MAINE MEDICAL CENTER
BRAMHALL CAMPUS
MRI #1 REPLACEMENT
PORTLAND, MAINE
ELEVATIONS, SECTIONS, AND
DETAILS

PROJECT MANAGER: DJV	PROJECT NO: 16004
AVE OF RECORD: DJV	
JOB CAPTAIN: MDR	
DRAWN BY: MDR	
SMRT FILE: AE103-16004	SHEET No. AE103

MRI ROOM E8
1/4"=1'-0"

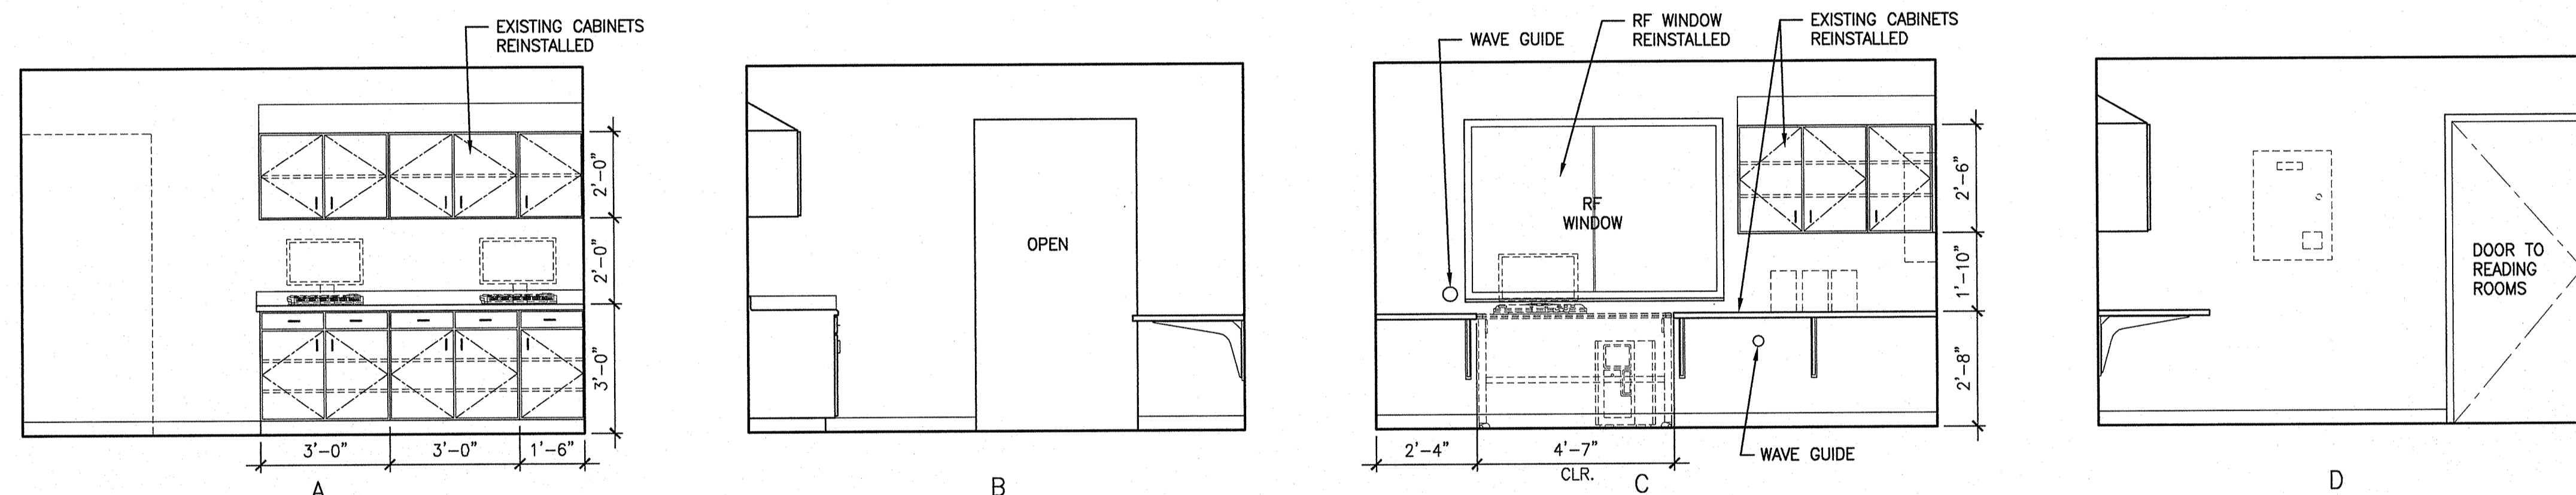
Does the new machine weigh more or less than the old?

GE 3t machine (to be removed): 17,312 lbs
Philips 1.5t (to be installed): 9921 lbs

CONTROL ROOM SECTION A2
1/4"=1'-0"

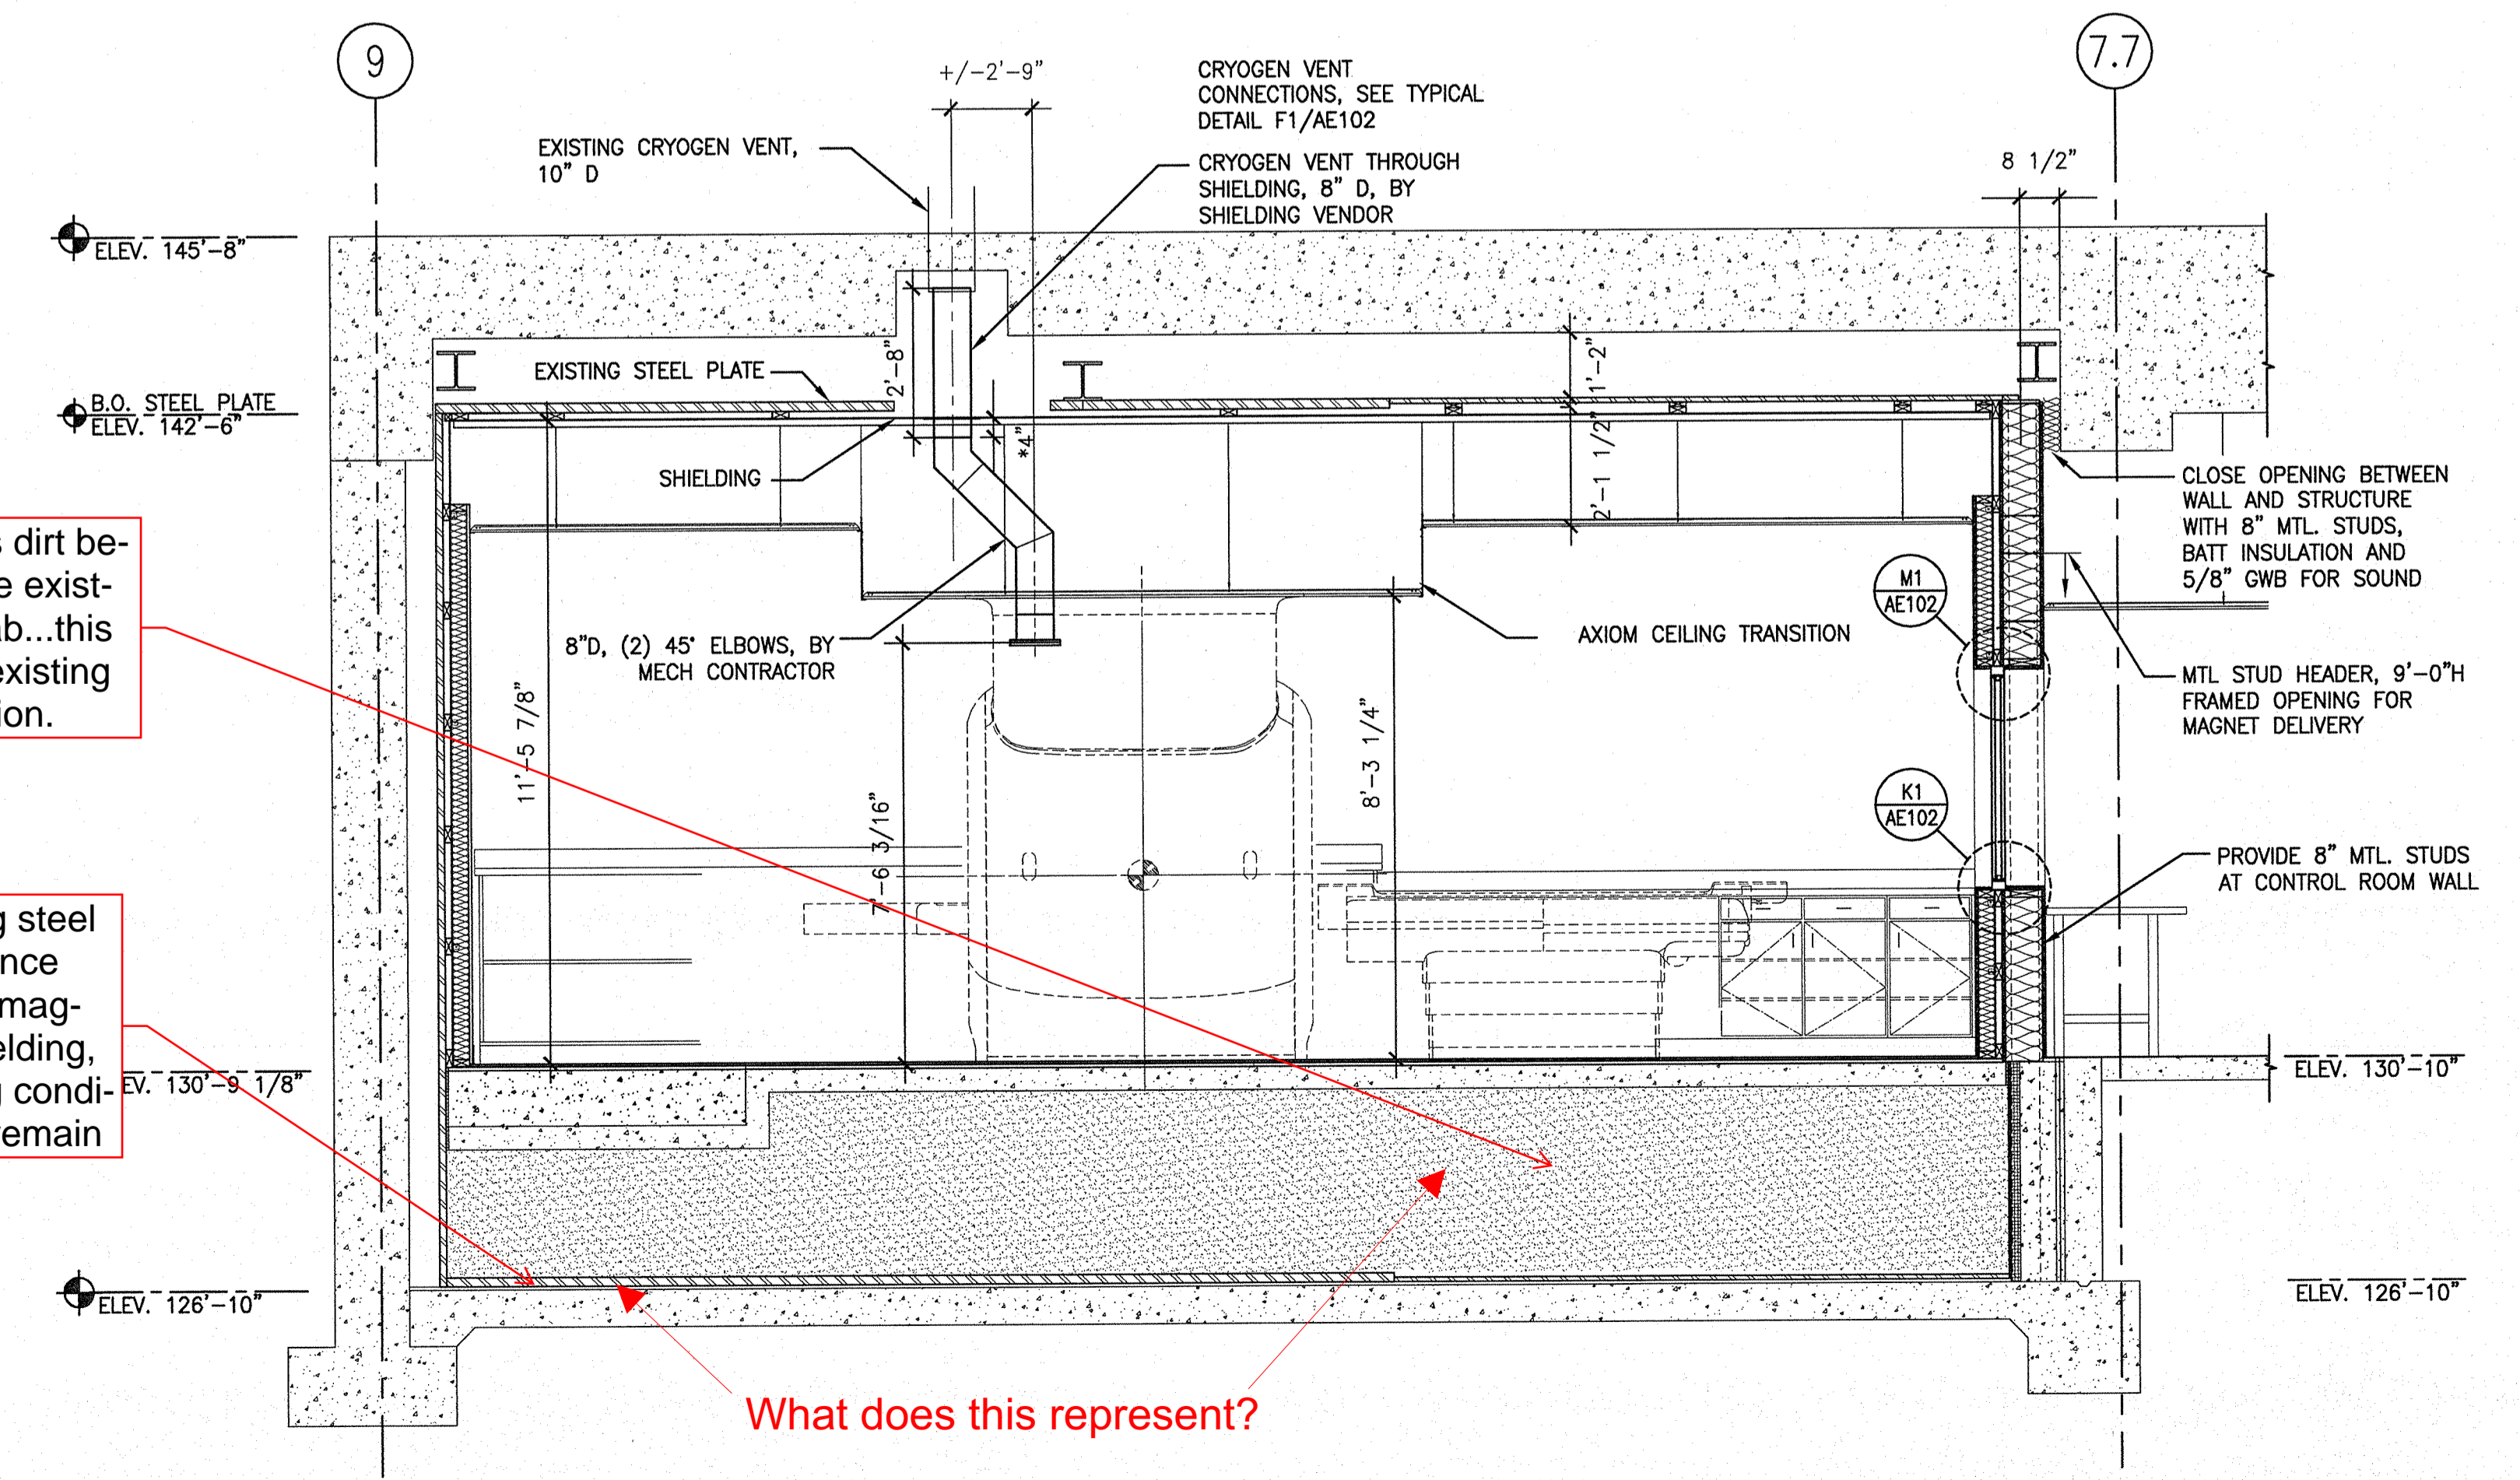
What does this represent?

Existing steel plate, once use as magnet shielding, existing condition to remain
